Item 5.**Development Application: 8 Point Street, Pyrmont - D/2022/51****File No.:** D/2022/51**Summary**

Date of Submission:	3 February 2022. Amended plans 19 April 2022 and 26 May 2022.
Applicant:	Ms Madeleine Dawson c/- Tzannes Associates Pty Limited
Architect:	Tzannes
Owner/Developer:	Mr Charanjit Singh and Ms Livleen Sodhi
Planning Consultant:	GYDE Consulting
Cost of Works:	\$695,730.00
Zoning:	The site is located in the B4 Mixed Use zone. Alterations and additions to a residential flat building is permissible in the B4 Mixed Use zone with consent.
Proposal Summary:	<p>The subject application seeks consent for alterations and additions to an existing residential apartment, including internal alterations, new and replacement windows, construction of an external laundry/bathroom, provision of a jacuzzi and outdoor kitchen, and construction of a deck and pergola.</p> <p>The proposal is referred to the Local Planning Panel for determination as the development is reliant on a clause 4.6 variation request to vary the floor space ratio development standard of the Sydney Local Environmental Plan 2012 (Sydney LEP 2012) by more than 10%.</p> <p>The applicant has lodged a written statem

Figure 30: View analysis showing proposed view from the level 9 terrace of Unit 48, with proposed additions circled red

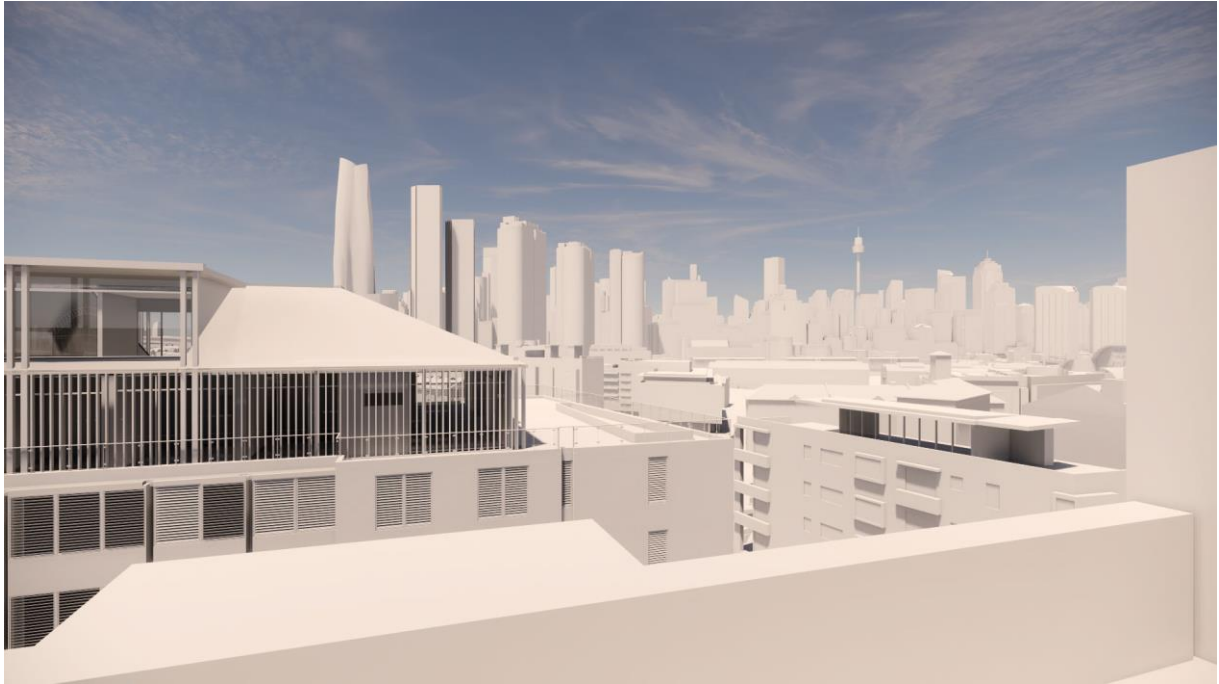
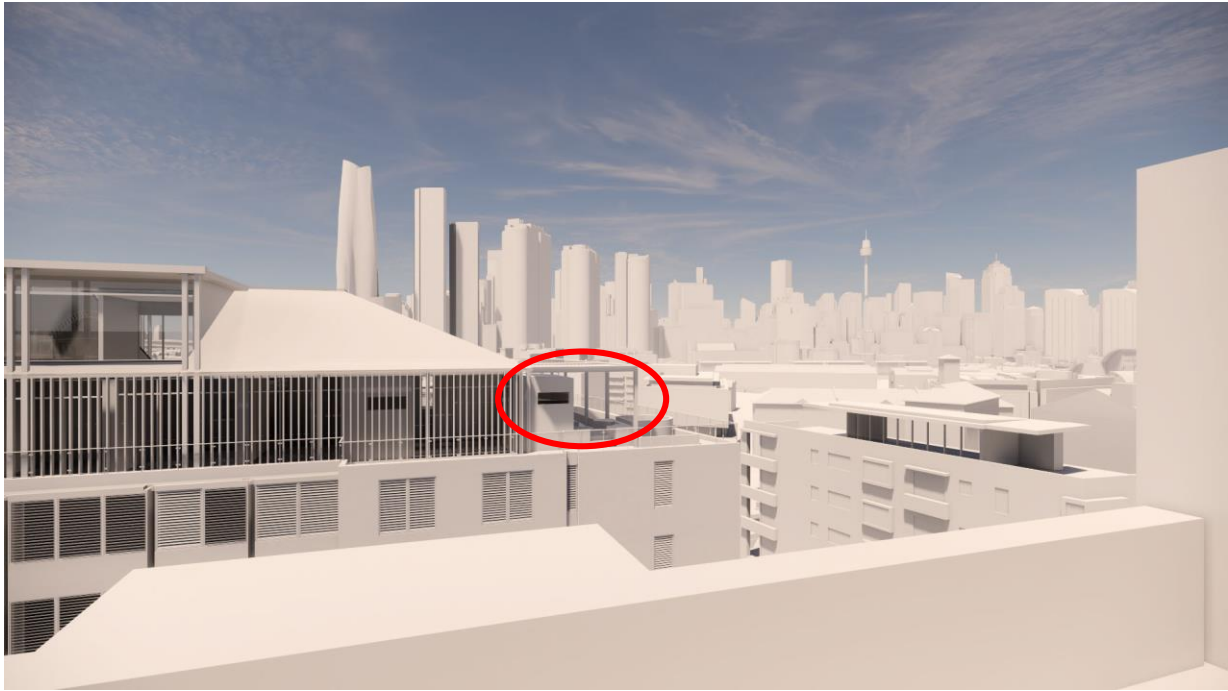
The most significant impact is from the level 9 terrace. As shown at Figure 29 and Figure 30, the proposal will only marginally reduce the extent of the city view obtained from the terrace area. While an extensive view of the city skyline, including of the Crown Tower, Barangaroo and Sydney Tower, will still be available, it is recognised that views to 'The Revy' apartment building will be lost or obscured from the southern end of the eastern terrace area.

- (d) Reasonableness: Unit 48 has frontages to both Point Street and Herbert Street. From levels 8 and 9, the apartment has a combined view of Sydney Harbour and the Sydney CBD skyline extending approximately 270 degrees. The extent of view loss, in comparison to the overall view available from the apartment, is considered extremely minor.

Figure 39: View analysis showing proposed view from the centre of the level 8 terrace of Unit 41, with proposed additions circled red

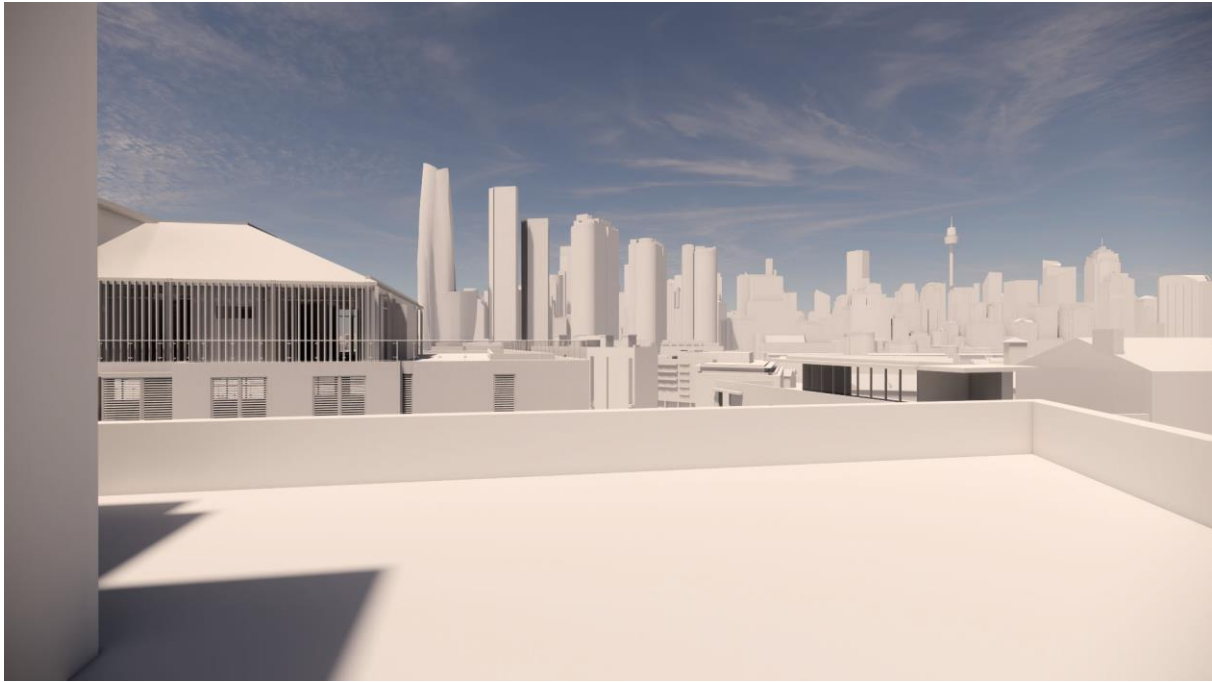
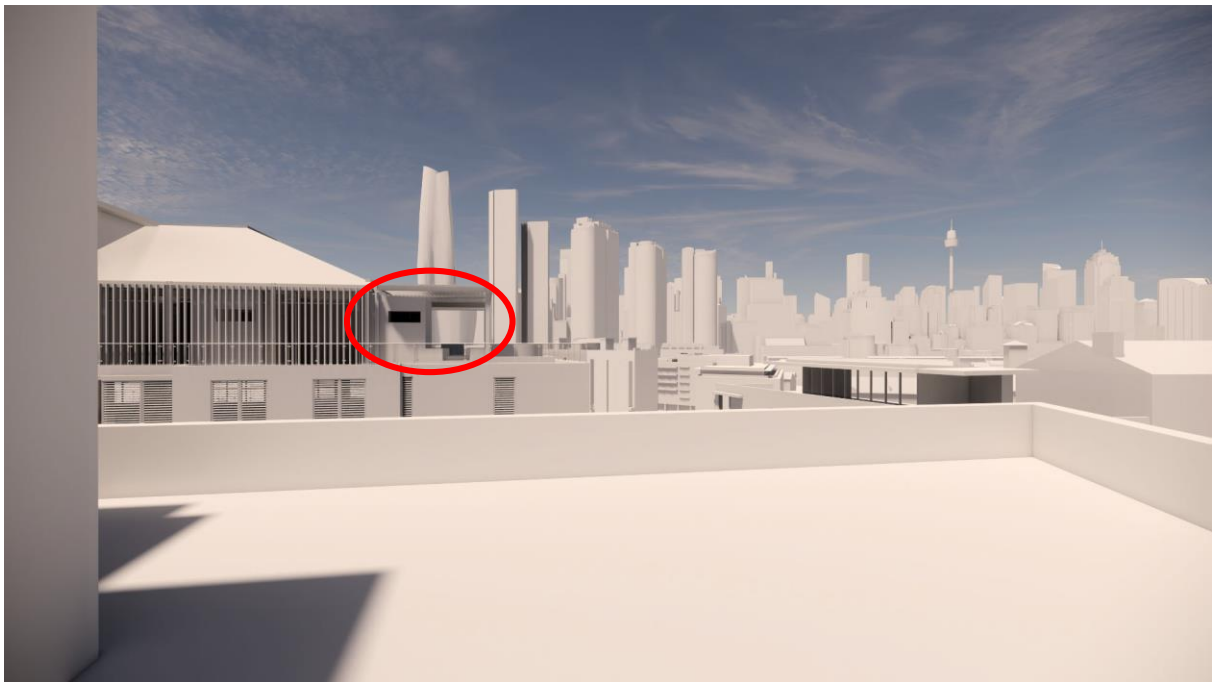
From the level 8 terrace, the impact is considered to be minor as the loss of city skyline view will be limited to the base of the Crown Tower and a small portion of the buildings adjoining Crown Tower. The wider city skyline, including views to Sydney Tower, will not be impacted as demonstrated in Figure 39.

Figure 44: View analysis showing the proposed view from the intersection of Bowman Street and Point Street, with proposed additions circled red

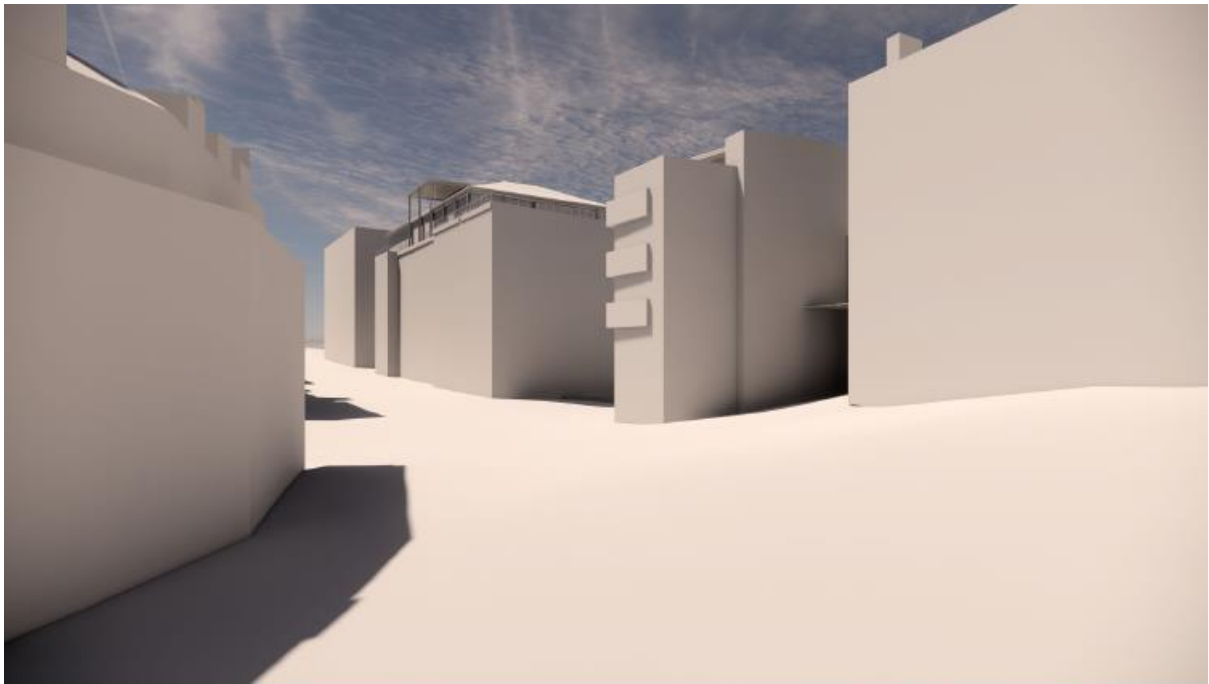
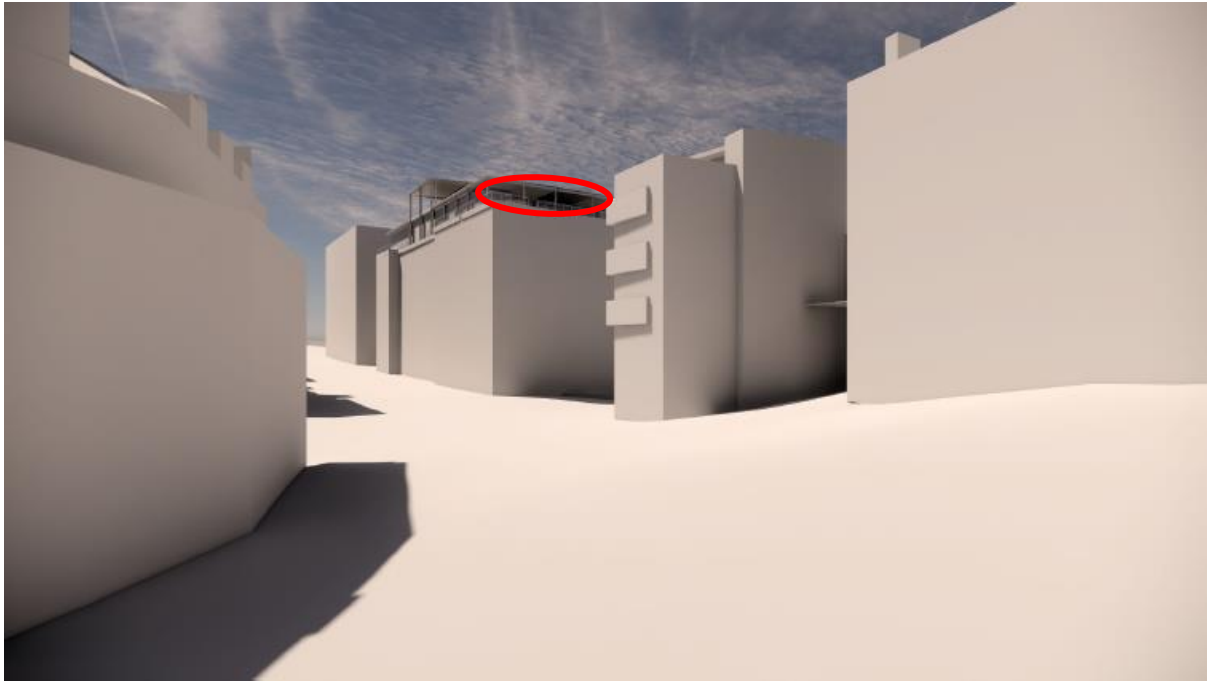
84. In relation to whether the proposed development will impact on the amenity of the public domain or any public view corridors, Figure 41 to Figure 44 demonstrate that the alterations and additions to the upper floor level of the 7-storey building will not be highly visible from the public domain.
85. The proposal results in a minor change to the bulk and massing of the building and results in no view loss impacts from the public domain. The proposal also does not result in any adverse overshadowing impacts on the public domain as discussed in the following section of this report. The proposal will therefore not have a detrimental impact on the amenity of the public domain.
